**TITLE: AUTO FLIGHT - AUTO FLIGHT - FCU - DEFINE AND INSTALL
HARDWARE FCU STD H6.0 WITH ENHANCED ENCODER
MANUFACTURING PROCESS**

116233L48546

This Service Bulletin is published to advise A350 aircraft operators of the issue of THALES AVIONICS S.A. Service Bulletin No. C31006A-22-005.

Figure ICN-A350-A-22XXP016-A-FAPE3-05VD0-A-001-01 Fig.SA Sol.AA SHEET 1/1

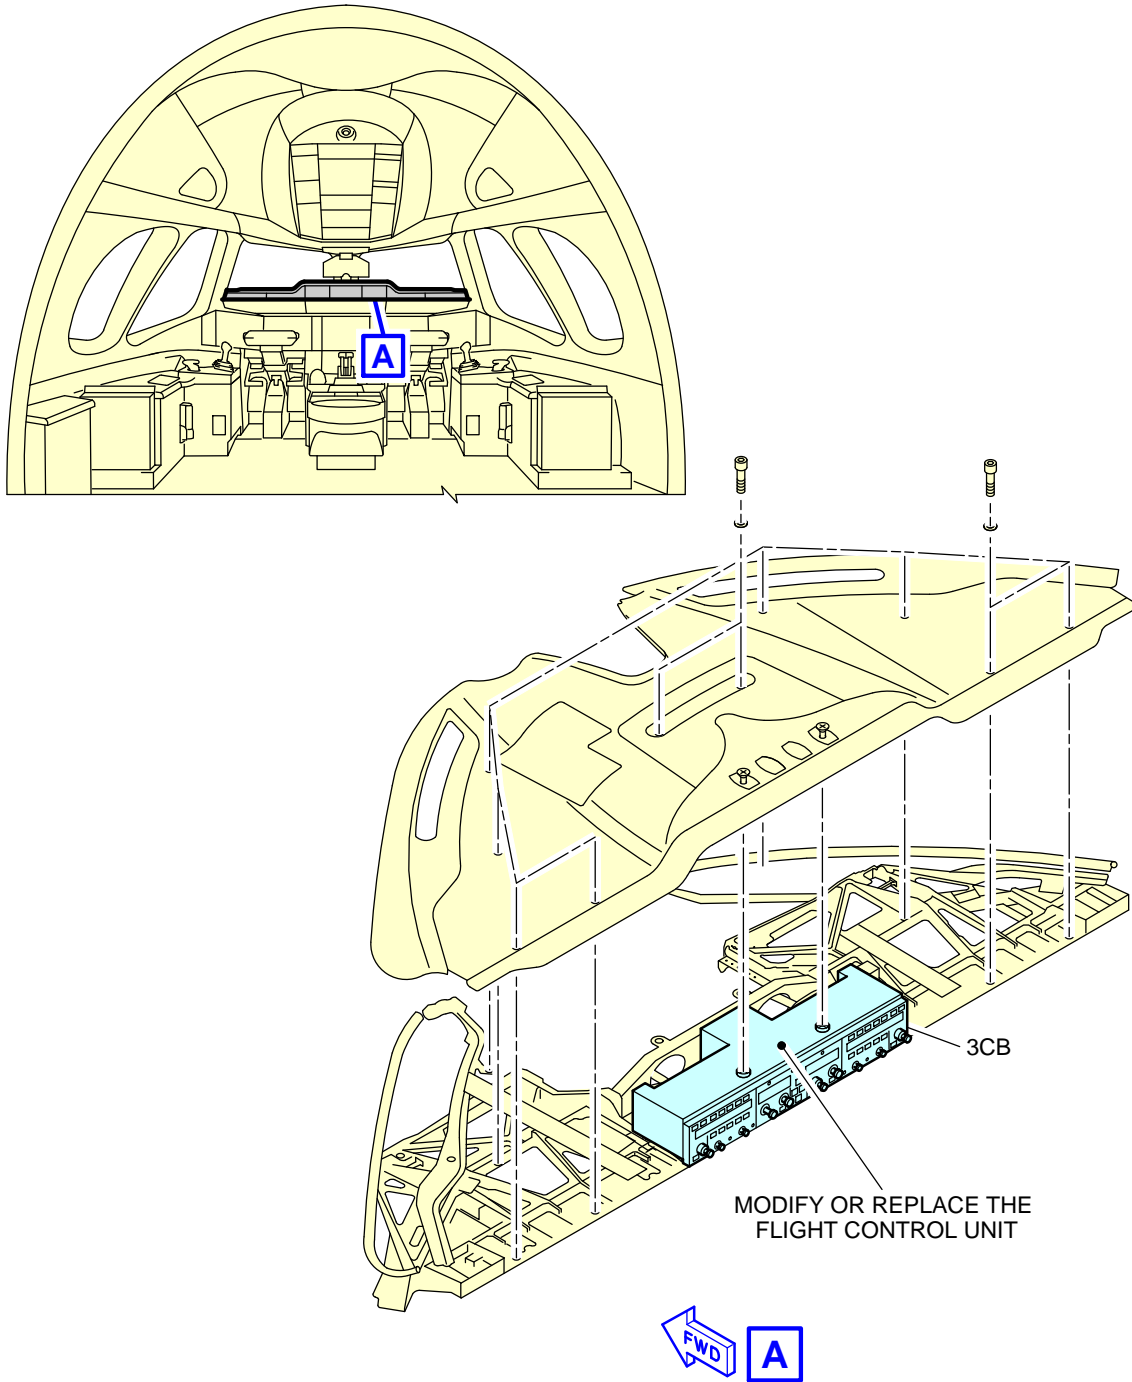
This Service Bulletin requires the installation of a new FCU standard H6.0 with enhanced encoder manufacturing process in place of FCU standard H5.0 installed by Mod. No. 107456L42463 to solve defective DC/DC converter.

The new FCU standard H6.0 will benefit from the modification of the production and control process in order to suppress the encoder position uncommanded turn that lead to ALT uncommanded.
